Subject: MHI's Responses to US-APWR DCD RAI 400-3032 Rev.0, 401-3031 Rev.0, 402-3028 Rev.0 and 403-3027 Rev.0

**Responses to Request for Additional Information No.400-3032
Revision 0**

**US-APWR Design Certification
Mitsubishi Heavy Industries
Docket No. 52-021**

RAI NO.: NO. 400-3032 REVISION 0
SRP SECTION: 11.05 – Process and Effluent Radiological Monitoring
Instrumentation and Sampling Systems
APPLICATION SECTION: 11.5
DATE OF RAI ISSUE: 06/18/2009

Figure 1 Containment Activity

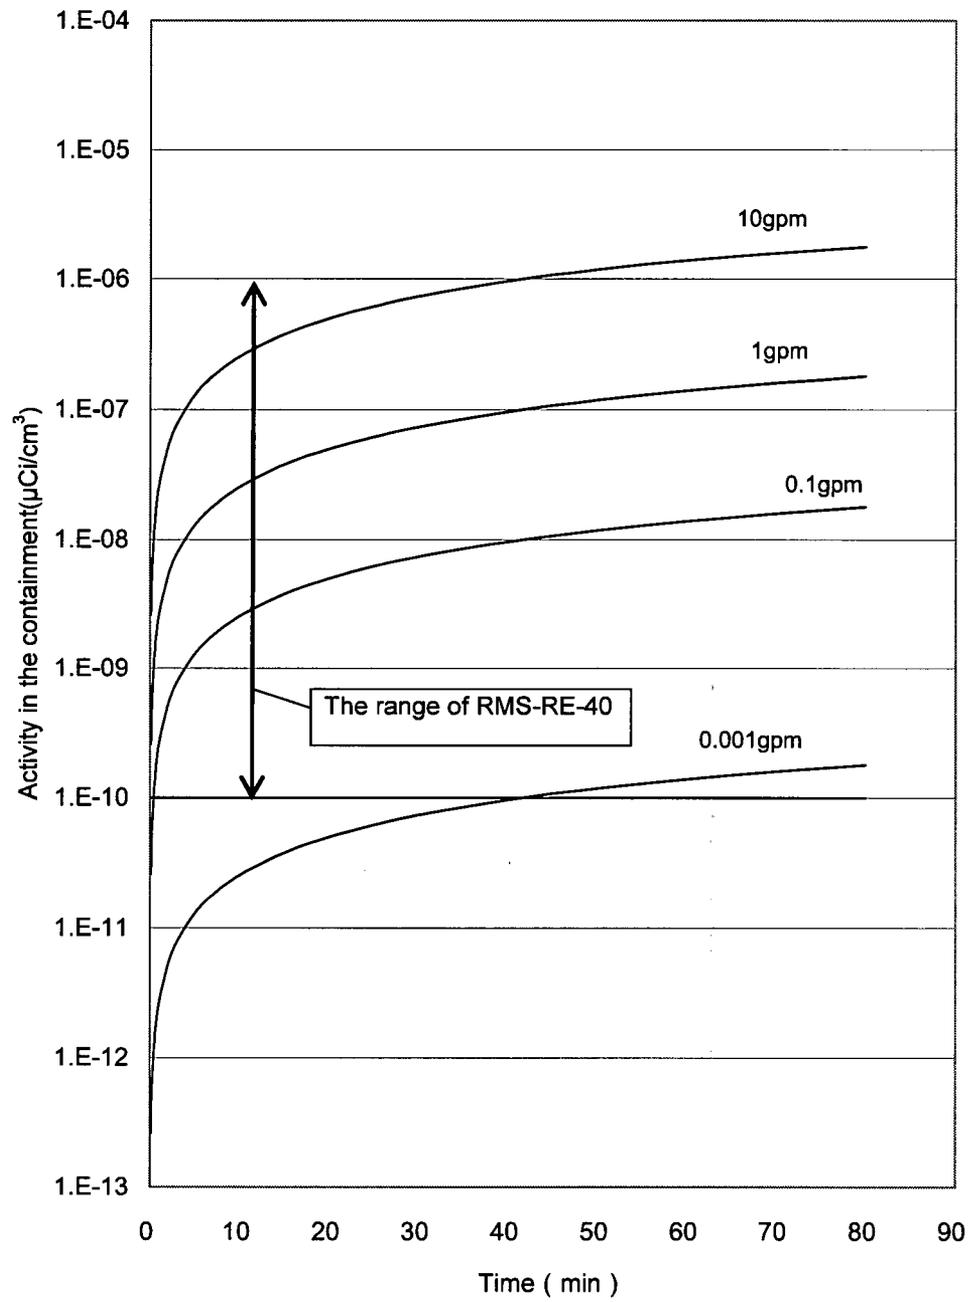
1. Submit a detailed evaluation which demonstrates that the containment particulate radiation monitor range provides the capability to detect leakage of "less than 0.5 gpm within one hour of detector response time" using a realistic radioactive concentration in the RCS, or describe the program and procedure that will be used to satisfy the RCS leakage rate technical basis and RG 1.45 (Rev 1). Revise the DCD to include this information and provide a markup in your response.
2. Update reference of RG 1.45 (Rev 0) to its current revision (Rev 1) in Table 1.9.1- 1 of DCD Section 1.9, and DCD Sections 5.2.5.4.1.2 and 5.2.7, and provide a markup in your response.

1. When reactor coolant leakage into the containment has occurred, the radioactivity concentration inside the containment increases is modeled by the following differential equation (Equation 1), based on an activity balance of the RCS. The integrated form of this equation is presented in Equation 2. The radioactivity inside the containment resulting from varying leakage rates was then calculated as a function of time, based on the parameters listed in Table 1. The results of this calculation are presented in Figure 1. Activity in the containment is detected by the containment radiation particulate monitor (RMS-RE-40) which has a range of 1×10^{-10} to 1×10^{-6} $\mu\text{Ci}/\text{cm}^3$ as listed in DCD Table 11.5-1 and indicated with arrows in Figure 1. This range ensures the capability to detect leakage of less than 0.5 gpm within one hour of detector response time.

Activity in the containment is calculated from the following equations.
